SUBJECT: Calvert Cliffs Nuclear Power Plant
Independent Spent Fuel Storage Installation
Material License No. SNM-2505, Docket No. 72-8
Responses to Request for Additional Information, RE: Calvert Cliffs Independent
Spent Fuel Storage Installation License Renewal Application

**CALVERT CLIFFS RESPONSE TO NRC REQUEST FOR ADDITIONAL
INFORMATION**

CALVERT CLIFFS NUCLEAR POWER PLANT, LLC
SPECIAL NUCLEAR MATERIALS LICENSE NO. 2505
DOCKET NO. 72-8
LICENSE RENEWAL REQUEST
FIRST REQUEST FOR ADDITIONAL INFORMATION

Figure 1

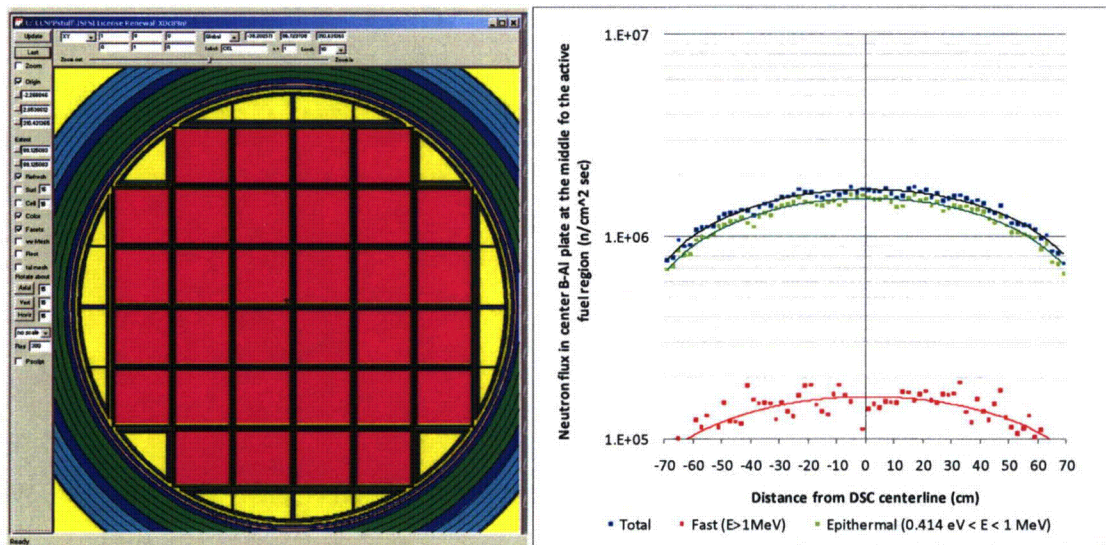
Provide a description of the expression and assumptions used in Appendix 8, ISFSI Time-Limited Aging Analysis Report, Section 4.1 for the calculation of the estimated total scalar neutron flux and the technical basis for the selection of parameter values used in the calculation.

In the Appendix 8, ISFSI Time-Limited Aging Analysis Report, Section 4.1, ISFSI Materials and Analyses Review of Poison Plates for the NUHOMS-32P, an approximation is used to estimate the total scalar neutron flux based upon a calculated scalar neutron flux. The applicant is requested to provide a description of the expression and assumptions used in the calculation of the estimated total scalar flux as well as a technical basis for the selection of parameter values used in the calculation.

CCNPP Response B-1:

The method utilized in Reference 1, Appendix B, Section 4.1, simply divided the design basis assembly neutron source for a NUHOMS-32P DSC by the inner surface area of a NUHOMS-32P DSC fuel cell. The use of the word scalar refers to the fact that neutron direction is ignored in this estimate and all source neutrons are assumed to pass through the fuel cell wall (i.e., axial leakage is ignored). To provide a second check of the approximation used in Reference 1, Appendix B, Section 4.1, Calvert Cliffs performed an independent check for this response using an in-house MCNP5 model of a NUHOMS-32P DSC containing the design basis neutron source from Calvert Cliffs Calculation CA06721, Section 6.5 (see ADAMS Accession Number ML091680542). The MCNP5 model was based on the transfer cask model used in Calvert Cliffs Calculation CA06750 (see ADAMS Accession Number ML091680544), modified to include an explicit model of the basket with homogenized fuel. A neutron flux mesh tally over the center poison plate was utilized to calculate the flux over the entire length of the poison plate. The results at the centerline of the active fuel region suggest that the method utilized in Reference 1, Appendix B may not reflect the peak neutron flux, which is calculated to be $1.69\text{E}6 \text{ n/cm}^2\text{s}$ at the center of the plate using MCNP5 model (as shown in Figure 1 below). The energy distribution of the flux is 93% epithermal ($0.414 \text{ eV} < E < 1 \text{ MeV}$) and 7% fast ($E > 1 \text{ MeV}$), with the thermal flux being negligible. This increases the 60 year fluence to $3.20\text{E}15 \text{ n/cm}^2$ using the same assumptions as in Reference 1, Appendix B, Section 4.1 (no decay in design basis source over 60 years). Note, however, that this does not alter the Section 4.1 conclusion that the 60 year fluence has a negligible impact on boron content of the plates, since 99.9993% of the boron would remain after 60 years even if every neutron was assumed to be absorbed by B-10. If actual B-10 reaction rates were considered based on the energy distribution of the flux, the depletion would be expected to be several orders of magnitude less.
